Project :	South West Milton Keynes (SWMK)		
Date:	14-02-2017	Ref:	1067760/TN14
Subject:	<b>Technical Note 14</b> – Response to Objection by Steve Heath

This Technical Note has been prepared in response to the objection submitted by Mr Steve Heath, a Newton Longville resident, to the planning application ref: 15/00619/FUL. The objection relates to the impact of traffic upon the local highway network under the control of Milton Keynes Council (MKC). A response is provided to the points raised under each section of the objection by Mr Heath.

Title WHADDON ROAD PROPOSED ACCESS VERTICAL VISIBILITY ENVELOPE

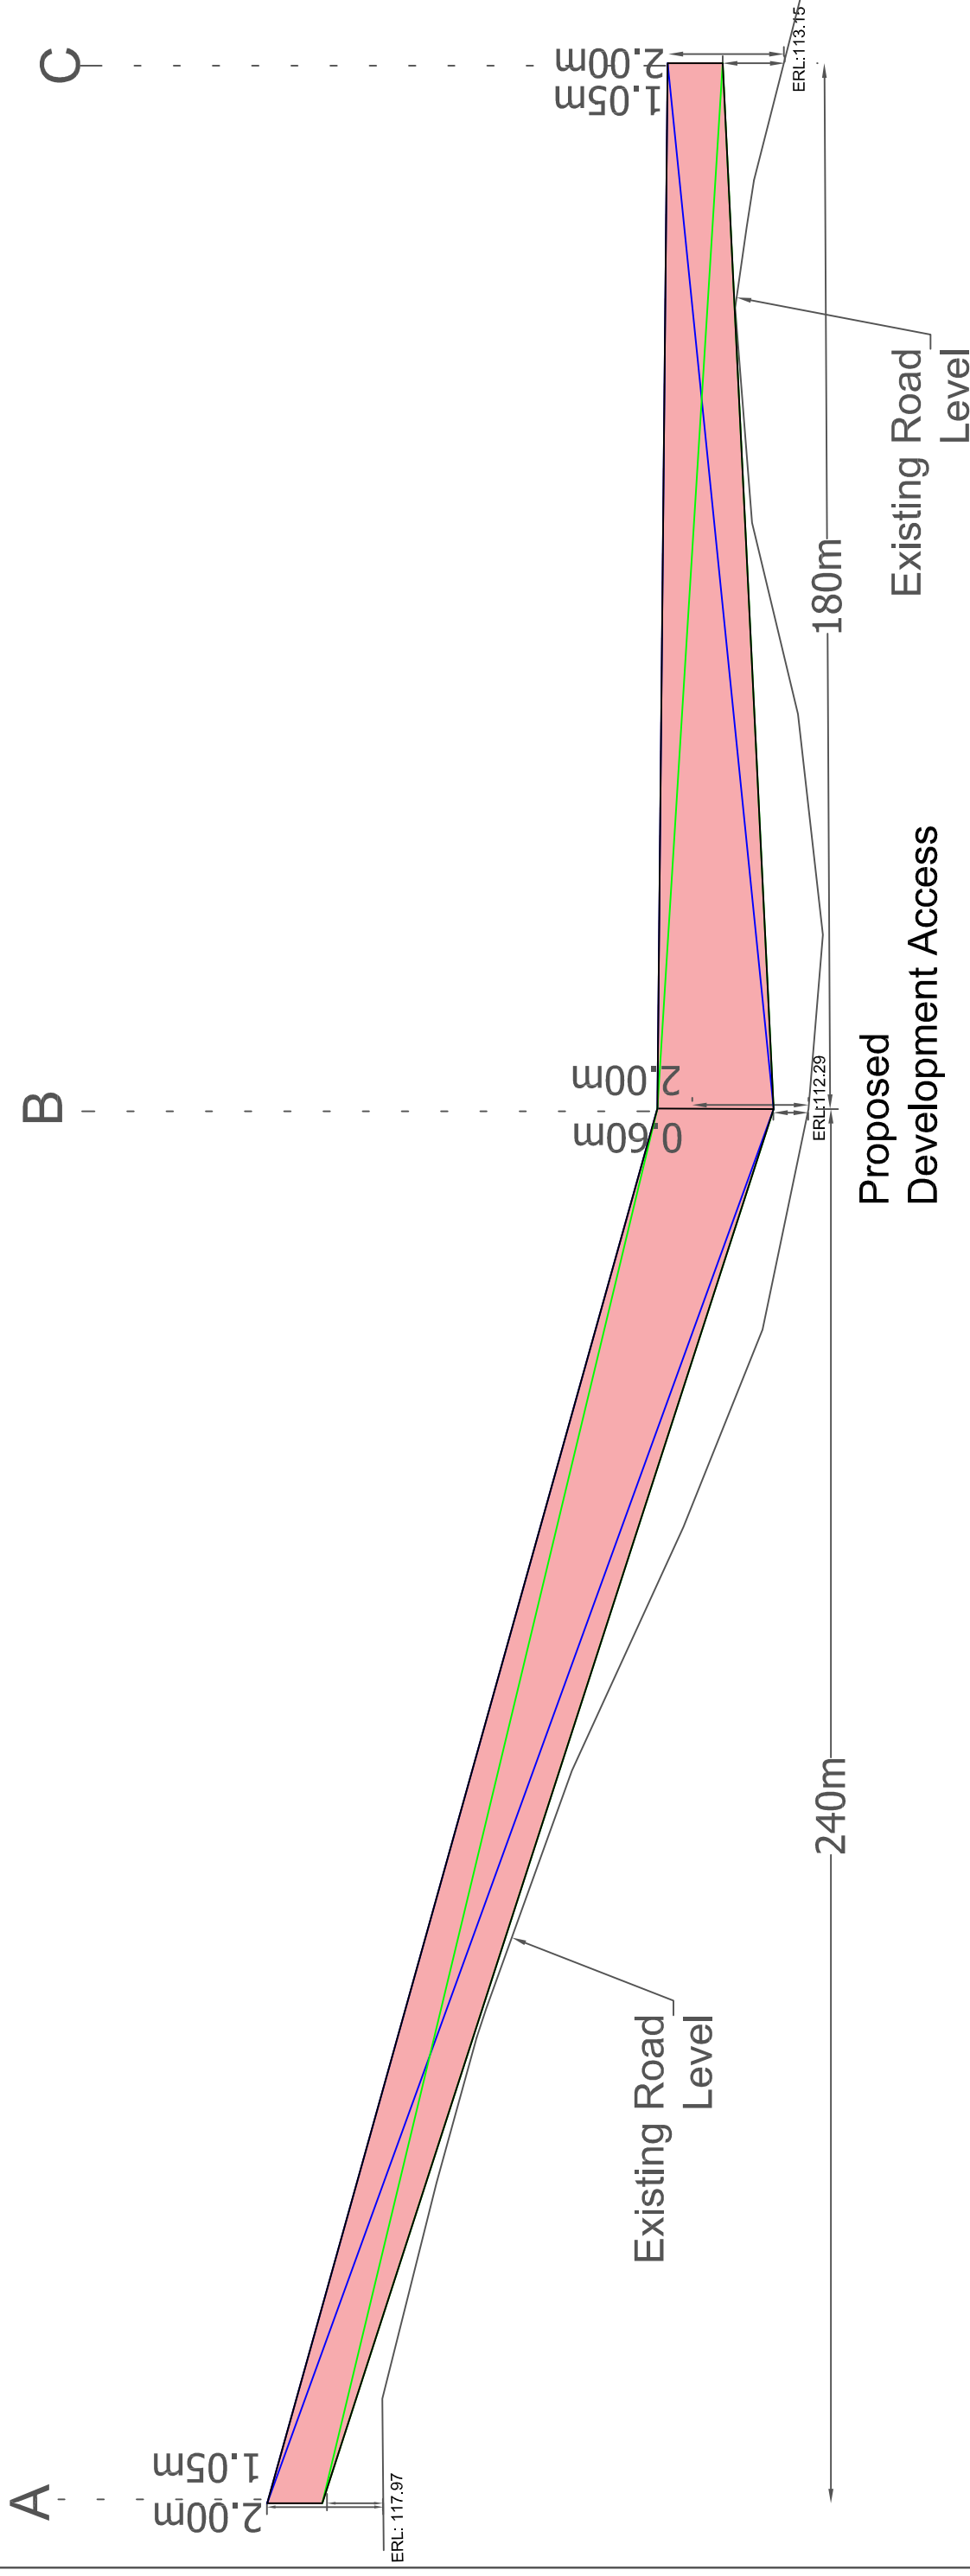
The visibility splays included within the previous Junctions8 modelling were set to 160m in both directions; the visibility as required by the standard set out in Manual for Streets (MfS). In reality, the actual available visibility along Whaddon Road is 240m to the left and 180m to the right of the proposed access, as detailed on Drawing D007C attached to this Note. These actual visibilities have been input to the revised Junctions8 modelling. Revised results for the Whaddon Road junction, including all Whaddon Road traffic, are provided in Tables 3a and 3b.

The development access location along Whaddon Road is suitable, appropriate and meets both vertical and horizontal visibility requirements, and is considered acceptable by an independent Stage 1 Road Safety Auditor. For avoidance of doubt - the location of the access point does not have ANY effect on traffic and safety at Bottle Dump roundabout.
